- 3. Granross Grove 2022 Replat; KPB File 2022-134
Mullikin Surveys / Baumgardner
Location: Ester Avenue & Granross Street
Anchor Area / Anchor Point APC**

ITEM 3 - GRANROSS GROVE 2022 REPLAT

KPB File No.	2022-134
Plat Committee Meeting:	September 26, 2022
Applicant / Owner:	Kent Baumgardner of Anchor Point AK
Surveyor:	Christopher Mullikin / Mullikin Surveys
General Location:	Ester Avenue, Anchor Point / Anchor Point APC

Granross Grove 2022 Replat A Lot line vacation Plat CREATING LOT 31B

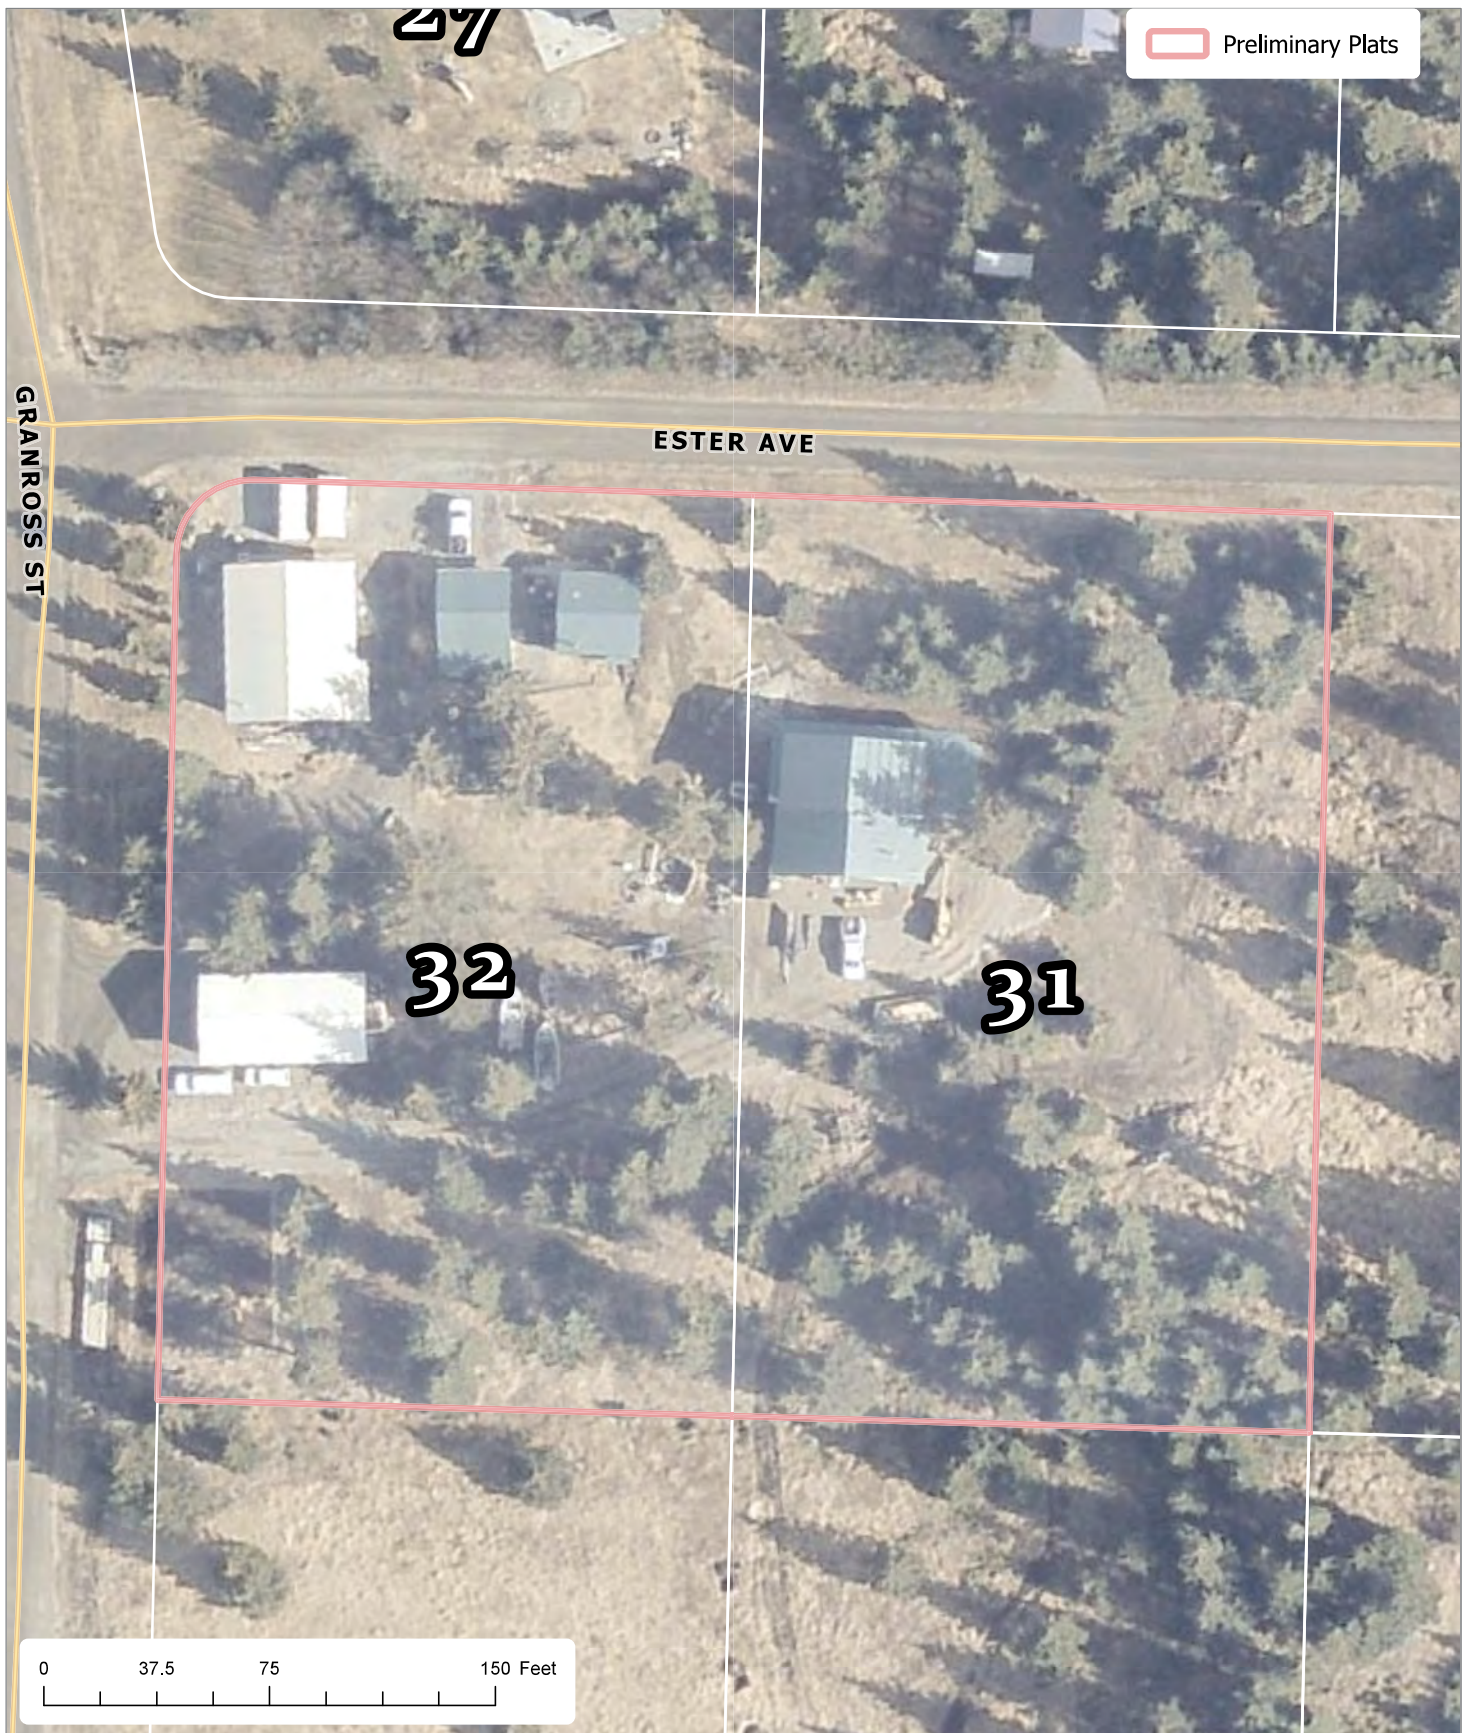
- *The Mullikin Surveys label above the title block is not required as the information is in the title block. If trying to include company logo, it can be incorporated into the title block or may remain.*
- *The line symbol for neighboring lot lines should be added to the legend.*
- *The legend states the one line symbol is for easement lines not surveyed but appears to be the former lot line.*
- *Add curve data to the curve in the northwest corner of Lot 31B.*

Staff recommendation: Remove the second line in the title: "A Lot line vacation Plat". Add KPB file number to title block 2022-134.

Staff recommendation: Add labels for land to the west across Granross Street and north of Ester Avenue. Change the font of the labels as reproduction could lose text. The depiction of neighboring properties only is required to 100 feet. The depiction of Laida Avenue is not required but may remain.

Staff recommendation: Surveyor should check the structures on parent Lot 32 for location to property lines and setbacks. If found to be an issue, show on drawing and add the following statement: "Acceptance of this plat by the Kenai Peninsula Borough does not indicate acceptance of any encroachments." Issues may be dealt with prior to final approval.

Plat note 6 may be removed.

Plat note 1 needs a correction to the lot number being created.

Plat note 2, please add the reference to KPB Code that allows for no field survey. "No field survey was conducted as provided in KPB Code 20.60.200(A)."

Staff recommendation: The certificate of ownership needs to be revised as it currently states right-of-way acquisition instead of subdivision. Update the year in the Notary's Acknowledgment. The plat approval note should comply with 20.60.190(C). Comply with 20.60.190.
